WARRENTON PLANNING COMMISSION
Regular Meeting | October 13, 2022 | 6:00pm
Warrenton City Hall Commission Chambers | 225 S Main Avenue, Warrenton, OR 97146

TO: The Warrenton Planning Commission
 FROM: Jay Blake, Planning Director *Jay Blake*
 DATE: October 13, 2022
 SUBJ: SUB 22-02: Buoy 10 Land Preliminary Plat
 Nathan Johnson, Sunrise Homes, Inc.
 Tax Parcel: 81009BC01100

**BUOY 10 LANDING SUBDIVISION
FOR TAXLOT 81009BC01100
PRELIMINARY SUBDIVISION PLANS
354 PACIFIC DRIVE, WARRENTON OR, 97121**

COMPOSITE SITE & UTILITY PLAN
BUOY 10 LANDING SUBDIVISION
354 PACIFIC DRIVE, WARRENTON, OR 97146

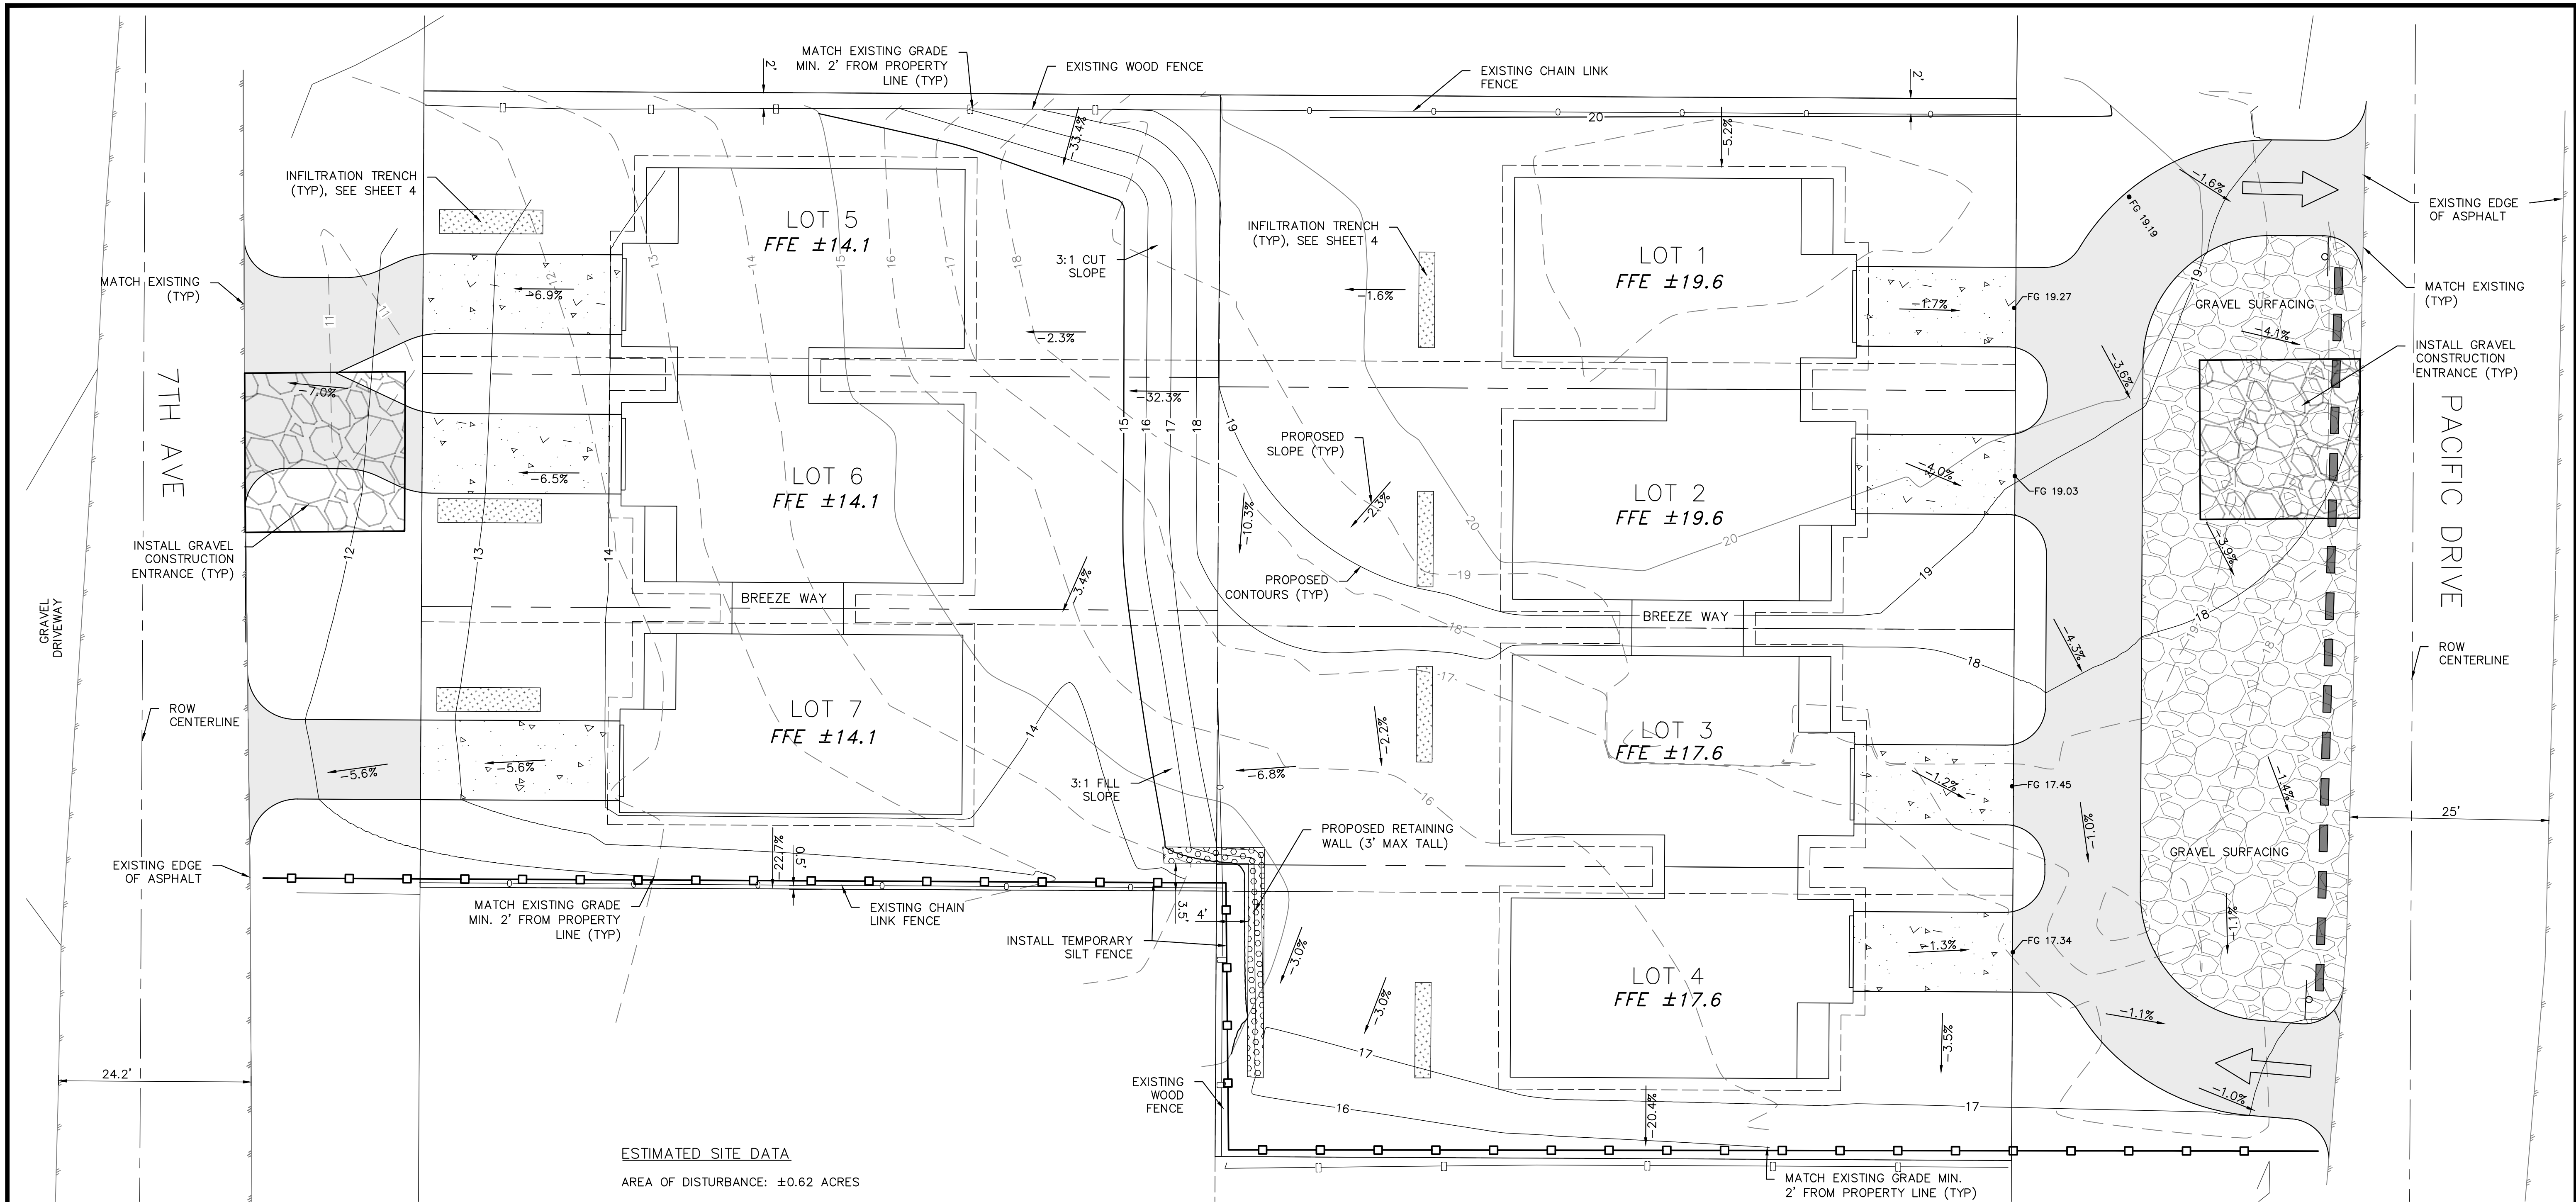
- Sheet 4 includes a table depicting each lot area, building footprint areas for all seven lots, and lot coverage for each lot.
- All lots are below the 40 percent lot coverage standard.
- All buildings will be 28 feet tall.
- The proposed structures meet required front yard, rear yard, and side yard setback requirements. Zero lot lines are allowed internally for attached single family structures.

- Initial engineering comments address the need to include all impervious coverage in stormwater management plans, including driveways and sidewalks. This should be addressed prior to final plat approval.
- Additional comments about stormwater planning are included in the engineering comments that were provided to the applicant.

- The applicant shall confirm shared driveway design approval with ODOT. The driveways should also meet size and separation requirements.
- Stormwater plans should address all run-off including driveways, this may require additional design and improvements adjacent or in public right-of-way.

- The site plan should include the location of a fire hydrant located within 250 feet of the buildings as required by the Fire Code. The applicant shall confirm that adequate flows exist to meet fire flow needs.

GRADING AND ESC PLAN
 BUOY 10 LANDING SUBDIVISION
 354 PACIFIC DRIVE, WARRENTON, OR 97146

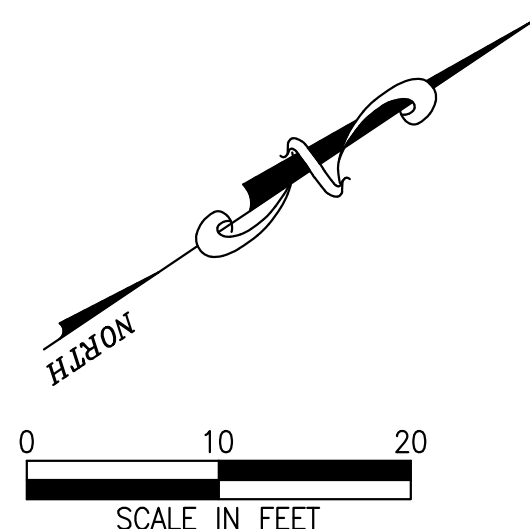
Sheet 5 illustrates the preliminary erosion control plan, which consists primarily of a temporary silt fence along the eastern property line from Hwy 104 to 7th Avenue. Upon completion of grading, the disturbed areas will be stabilized until building construction is completed on each lot and permanent landscaping is installed. A final erosion control plan will be prepared and submitted with the grading permit application after preliminary plat approval. This standard is satisfied.
